Entergy Operations, Inc.
P. O. Box 756
Port Gibson, MS 39150

GNRO-2010/00067

SUBJECT: License Amendment Request to Implement TSTF-493 for Condensate Storage Tank Low Level Setpoint
Grand Gulf Nuclear Station, Unit 1
Docket No. 50-416
License No. NPF-29

Analysis of Proposed Technical Specification Changes

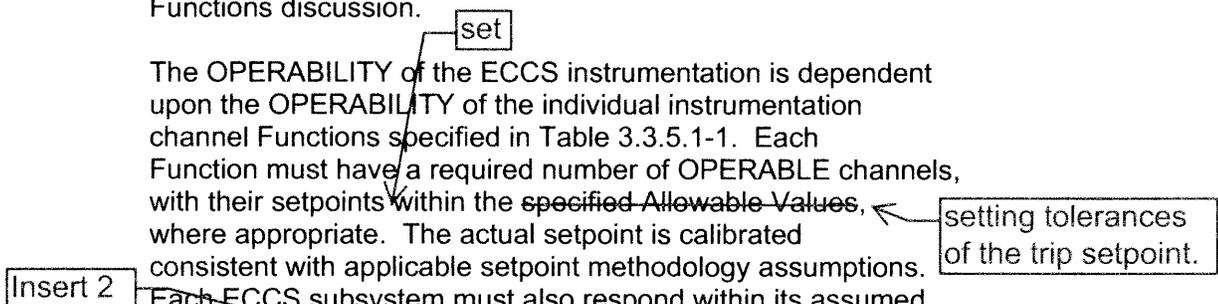
~~Allowable Values are specified for each ECCS Function specified in the table. Nominal trip setpoints are specified in the setpoint calculations. The nominal setpoints are selected to ensure that the setpoints do not exceed the Allowable Value between CHANNEL CALIBRATIONS. Operation with a trip setpoint less conservative than the nominal trip setpoint, but within its Allowable Value, is acceptable. A channel is inoperable if its actual trip setpoint is not within its required Allowable Value. Trip setpoints are those predetermined values of output at which an action should take place. The setpoints are compared to the actual process parameter (e.g., reactor vessel water level), and when the measured output value of the process~~

parameter exceeds the setpoint, the associated device (e.g., trip unit) changes state. The ~~analytic limits are derived~~ from the limiting values of the process parameters ~~obtained~~ from the safety analysis. The Allowable Values are derived from the ~~analytic limits~~, corrected for calibration, process, and some of the instrument errors. The trip setpoints are then determined, accounting for the remaining instrument errors (e.g., drift). The trip setpoints derived in this manner provide adequate protection because instrumentation uncertainties, process effects, calibration tolerances, instrument drift, and severe environment errors (for channels that must function in harsh environments as defined by 10 CFR 50.49) are accounted for.

Insert 2

Allowable Values are specified for each ECCS Function specified in Table 3.3.5.1-1. For Function 3.d, Condensate Storage Tank Level-Low, the nominal trip setpoint and methodologies for calculation of the as-left and as-found tolerances are described in the Technical Requirements Manual. The trip setpoints are selected to ensure that the setpoints remain conservative to the as-left tolerance band between CHANNEL CALIBRATIONS. After each calibration the trip setpoint shall be left within the as-left band around the nominal trip setpoint.
